#### Docket No. 060368-WS

# Application to Increase Rates and Charges For a "Class A" Utility In

# Aqua Utilities Florida, Inc. Sanitary Survey Reports

Water Systems

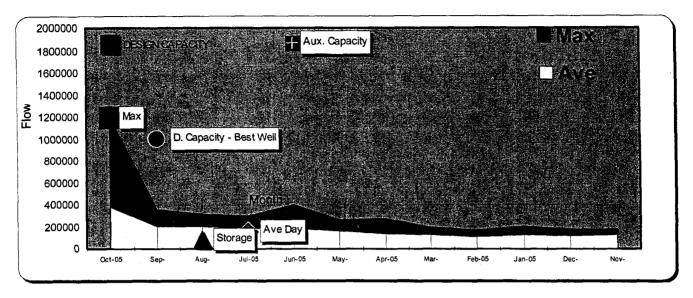
The Department recommends that a PM program be established and implemented to prevent system failures and sanitary deficiencies. The Department is pleased that the hiring of additional personnel is planned for this year to assist with this effort.

### Flow & Capacity and Population Graphs

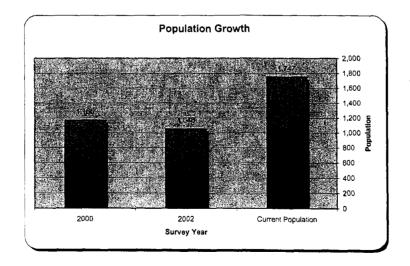
This system is expanding due to a new round of home building within the development. The graph above shows that the system has experienced a gradual growth in demand through the past twelve months. Analysis of the system's capacity is complicated by the fact that Well #1 and its 70,000 gallons of storage are currently offline for upgrades, but are due to be back online soon. The production spike of 1.2M gallons seen in October 2005 may have been due to the flushing of Well #1 (as an attempt was being made to bring it back online), so this max day figure should likely be disregarded. If the 400,500 gallon demand seen in June 2005 is used instead, and the 70,000 gallon storage at Well #1 (currently offline) is included, the total storage capacity of 87,500 gal is still less than ¼ of max day, at 21.85% of max day (about 13% under the storage needed to achieve the recommended 25% of max day level). Comparing total storage to an average day (again with Well #1's tanks included and without the extraordinary October 2005 demand), storage still falls short at only 57% of demand. As such, additional storage should be considered. Source capacity without Well #1 (max day as % of design capacity) is at 34%; with Well #1 it is 21%, both of which are in compliance. Figures for auxiliary capacity are similar, since all three wells have auxiliary power and are capable of full output even in emergency conditions.

After a slight drop in population between years 2000 and 2002, growth has begun anew, with 700 more served by the franchise, and 56 service connections having been added since the last survey in 2004. At least 90 more connections are planned for this year.

### Deficiencies:

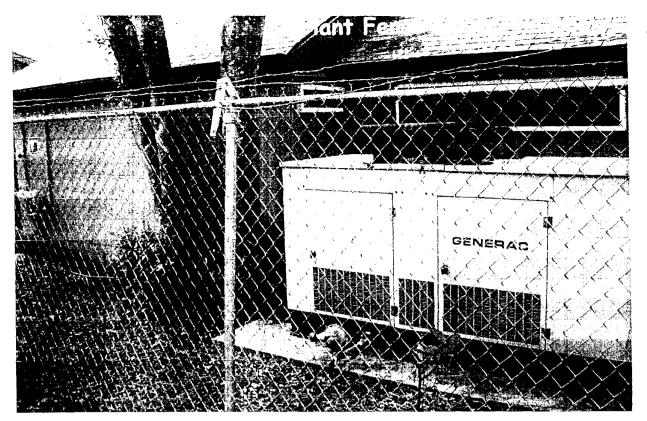
- 1.) Water plant fence and top barbed wire damaged. (62-555.350 Florida Administrative Code= F.A.C.)
- 2.) No record of cross connection control plan implementation by current owner. (62-555.360 F.A.C.)
- 3.) No documentation of Phosphate concentration in finished water. (Chapter 62-555.35 F.A.C.)

- 1.) Submit updated Lead/Copper sample plan with increased tap sample and water quality sites.
- 2.) Document annual cleaning of storage tanks and certified tank inspections every five years.
- 3.) Consolidate all equipment manuals into one bound and indexed notebook. (Due: 12/31/05)
- 4.) Create Emergency Response Plan by 12/31/05.
- 5.) Install audio-visual alarm system for power outage or auxiliary power source operation.
- 6.) Exercise key isolation valves and maintain updated distribution system map.
- 7.) Document all legitimate customer complaints and operator responses in a log book.
